#### **Addendum 8 – UN Regulation No. 9**

#### **Revision 4 - Amendment 2**

Supplement 2 to the 08 series of amendments – Date of entry into force: 8 October 2022

#### **Uniform provisions concerning the approval of category L<sub>2</sub>, L<sub>4</sub> and L<sub>5</sub> vehicles with regard to sound emission**

"Figure 1

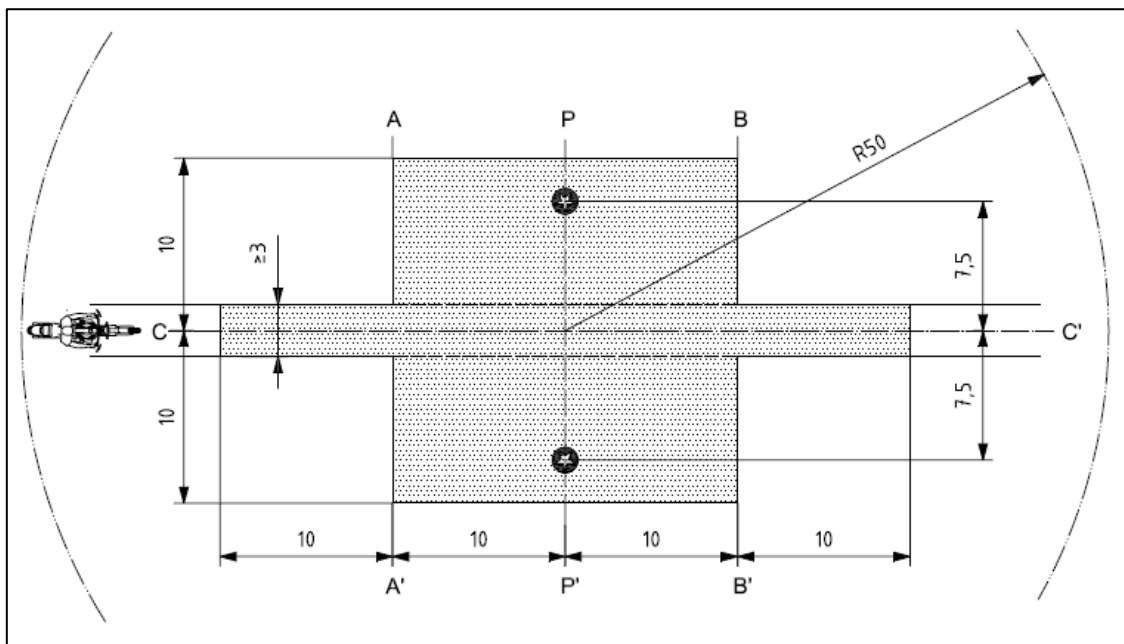
Figure 1, amend to read:

**Test track layout with dimensions in meters**

Source: ISO 10844:1994, with modifications."
